From: Tim Walsh <tim@novogroup.co.nz>
Sent: Thursday, 6 July 2023 8:41 am
To: Cottam, Rachel
Cc: Ben Owen; Higgins, John; Richard Peebles; Jorgensen, Craig; Lowe, Paul
Subject: RE: RMA/2022/3611 - Request for further information 320A Cumnor Terrace
Attachments: Letter to Tim Walsh regarding Portlink application.pdf; FW: Portlink Stages 6,7 and 8 - Tree Report

From: Cottam, Rachel <Rachel.Cottam@ccc.govt.nz>
Sent: Friday, May 26, 2023 11:07 AM
To: Tim Walsh - Novo Group <tim@novogroup.co.nz>
Cc: Ben Owen <ben@peeblesgroup.co.nz>; Higgins, John <John.Higgins@ccc.govt.nz>; Richard Peebles <richard@peeblesgroup.co.nz>; Jorgensen, Craig <Craig.Jorgensen@ccc.govt.nz>; Lowe, Paul <Paul.Lowe@ccc.govt.nz>
Subject: RMA/2022/3611 - Request for further information 320A Cumnor Terrace

BRAEBURN PROPERTY LIMITED: APPLICATION IN RELATION TO 320 & 320A CUNMOR TERRACE

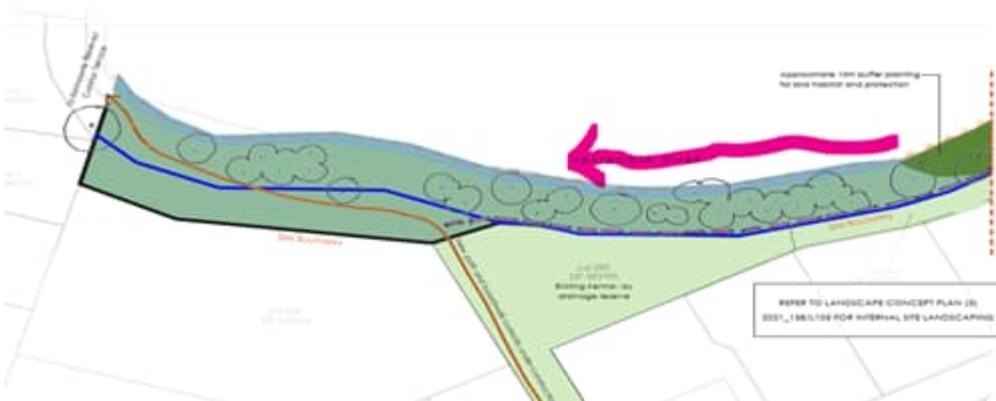
The ecologists are relatively happy with the proposed landscaping plan subject to the comments below. There may be some detailed conditions in terms of landscaping. The bird habitat needs to be extended to the H in the Heathcote river as shown above however the lizard habitat can remain as proposed on the plans. In terms of the haulage route, the area will be sheet/shaped to flow gently to the river (sloped 2% to the top of the bank) and will require the illegal channel to be filled as part of these works.
